UNITED STATES PATENT AND TRADEMARK OFFICE

APPLICATION NO.	FILING DATE	FIRST NAMED INVENTOR	ATTORNEY DOCKET NO.	CONFIRMATION NO.
10/061,699	02/01/2002	Scott C. Young	LEG03 P-317	1548

Office Action Summary

Attachment A

F21B34

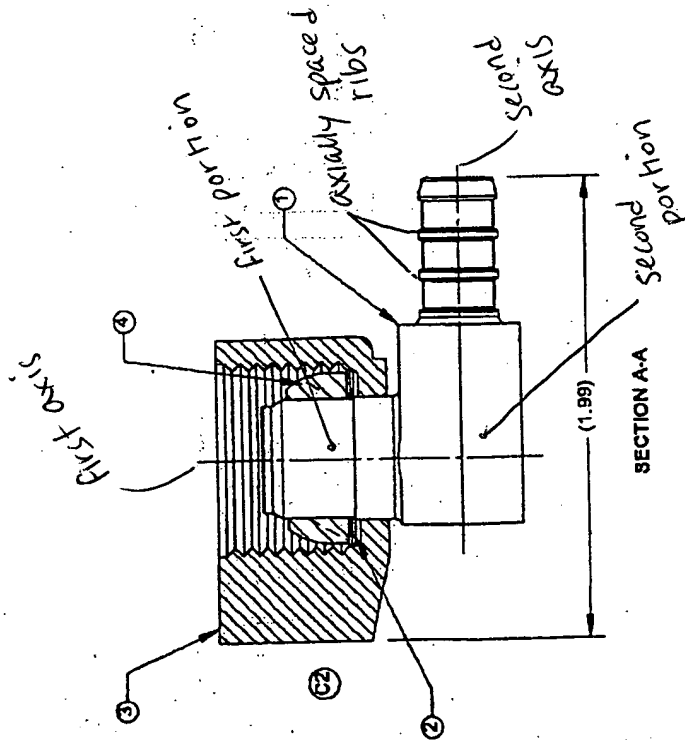
With respect to claim 1, the document depicting Marshall Brass' Part F21B34 (hereinafter "The F21B34 document") shows a swivel drop ear elbow fitting comprising: a threaded nut (3) including a plurality of integrated ears (see Attachment A) located along an external periphery of the threaded nut; a retaining ring (2); and a hollow elbow adapter (1) including a first portion centrally positioned with respect to a first axis (see Attachment A) and a second portion centrally positioned with respect to a second axis (see Attachment A), wherein the second axis is not colinear with the first axis, and wherein an outer surface of the first portion is shaped to receive the retaining ring (see "Section A-A") which retains the threaded nut on the first portion of the hollow elbow adapter while allowing the hollow elbow adapter to rotate (swivel) with respect to the threaded nut. The F21B34 document does not disclose that the ears include an aperture for receiving a fastener for securing the threaded nut to a stationary support. The F26B44 document teaches a drop ear elbow fitting having a plurality of attachment ears each with an aperture therein for securing the threaded nut of the fitting to a support (stationary or otherwise). In view of the teaching of document F26B44, it would have been obvious to one having ordinary skill in the art at the time the invention was

With respect to claim 6, wherein an outer surface of the second portion of the hollow elbow adapter includes a plurality of axially spaced ribs (see Attachment A).

With respect to claim 10, the document depicting Marshall Brass' Part F21B34 (hereinafter "The F21B34 document") shows a swivel drop ear elbow fitting comprising: a threaded nut (3) including a plurality of integrated ears (see Attachment A) located

along an external periphery of the threaded nut; a retaining ring (2); and a hollow elbow adapter (1) including a first portion centrally positioned with respect to a first axis (see Attachment A) and a second portion centrally positioned with respect to a second axis (see Attachment A), wherein the second axis is not colinear with the first axis, and wherein an outer surface of the first portion is shaped to receive the retaining ring (see "Section A-A") which retains the threaded nut on the first portion of the hollow elbow adapter while allowing the hollow elbow adapter to rotate (swivel) with respect to the threaded nut; and a seal (4) with an inner diameter sized to receive the first portion of the hollow elbow adapter and an outer diameter sized to substantially eliminate fluid leakage between the end fitting and an external fitting that is threadingly received by the threaded nut* (see above Note). The F21B34 document does not disclose that the ears include an aperture for receiving a fastener for securing the threaded nut to a stationary support. The F26B44 document teaches a drop ear elbow fitting having a plurality of attachment ears each with an aperture therein for securing the threaded nut of the fitting to a support (stationary or otherwise). In view of the teaching of document F26B44, it would have been obvious to one having ordinary skill in the art at the time the invention was made to modify the ears of the F21B34 document with apertured attachment ears in order to permit the threaded nut of F21B34 to be attached to a support.

With respect to claim 15, wherein an outer surface of the second portion of the hollow elbow adapter includes a plurality of axially spaced ribs (see Attachment A).

With respect to claim 17, the document depicting Marshall Brass' Part F21B34 (hereinafter "The F21B34 document") shows a swivel drop ear elbow fitting comprising: a threaded nut (3) including a plurality of integrated ears (see Attachment A) located along an external periphery of the threaded nut; a retaining ring (2); and a hollow elbow adapter (1) including a first portion centrally positioned with respect to a first axis (see Attachment A) and a second portion centrally positioned with respect to a second axis (see Attachment A), and wherein an outer surface of the first portion is shaped to receive the retaining ring (see "Section A-A") which retains the threaded nut on the first portion of the hollow elbow adapter while allowing the hollow elbow adapter to rotate (swivel) with respect to the threaded nut; and a cone-shaped seat (4) made of elastomeric material (santoprene) with an inner diameter sized to receive the first portion of the hollow elbow adapter and an outer diameter sized to substantially eliminate fluid leakage between the end fitting and an external fitting that is threadingly received by the threaded nut* (see above Note). The F21B34 document does not disclose that the ears include an aperture for receiving a fastener for securing the

With respect to claim 20, wherein an outer surface of the second portion of the hollow elbow adapter includes a plurality of axially spaced ribs (see Attachment A).
